Technical Service Information

THM 4L60-E/4L65-E AND THM 4L80-E NEW PRESSURE CONTROL SOLENOID

Figure 1

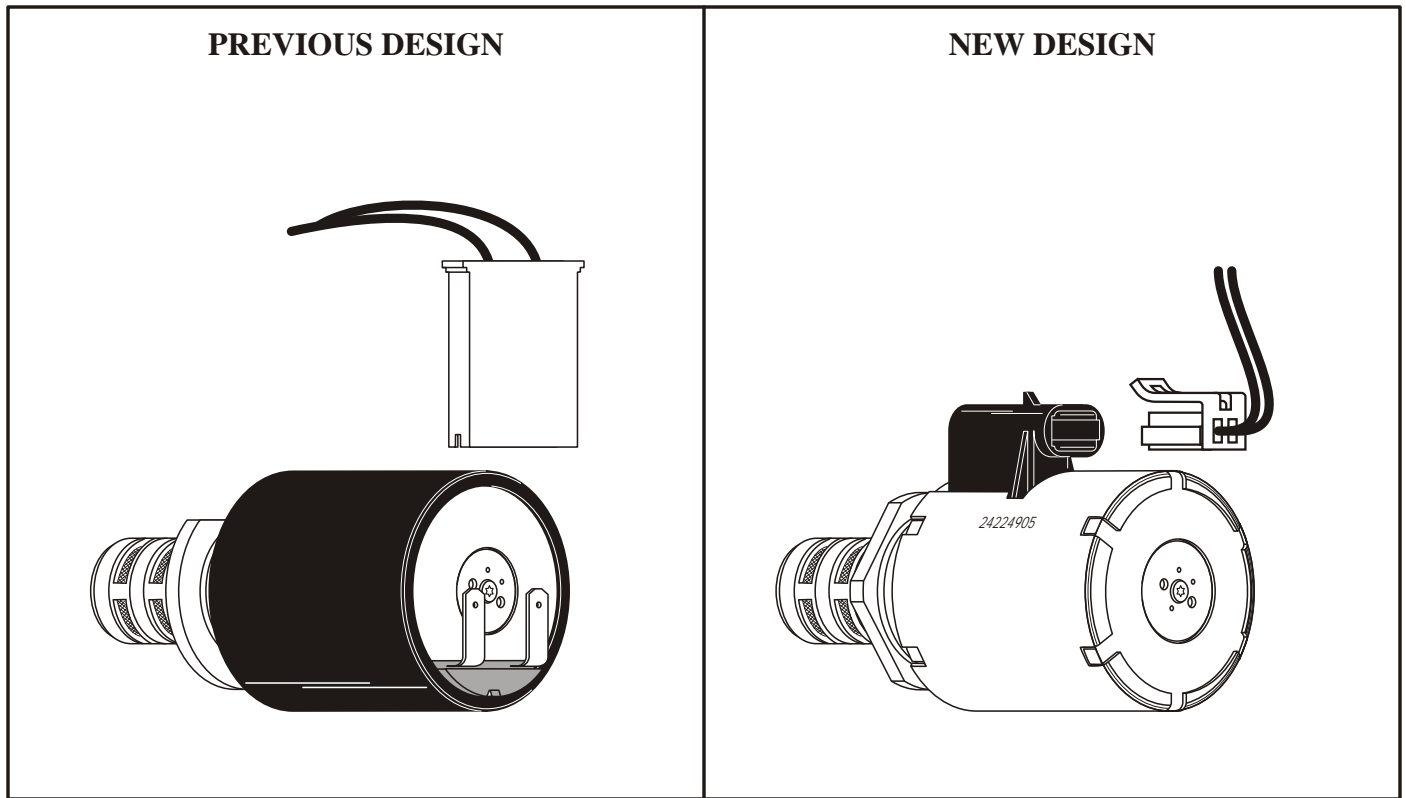
CHANGE: Beginning at the start of production for 2003 model 4L60-E and 4L65-E transmissions, and start of production for 2004 model 4L80-E transmissions, the Pressure Control Solenoid (PCS) was changed to a new design solenoid with a revised internal harness connector, as shown in Figure 1.

- (1) **PRESSURE CONTROL SOLENOID** - Solenoid redesigned with a new design connector, as shown in Figure 1.
- (2) **INTERNAL WIRE HARNESS** - Harness connector changed to accommodate the new solenoid connector, as shown in Figure 1.

Will interchange as long as the internal harness used is compatible with the solenoid.
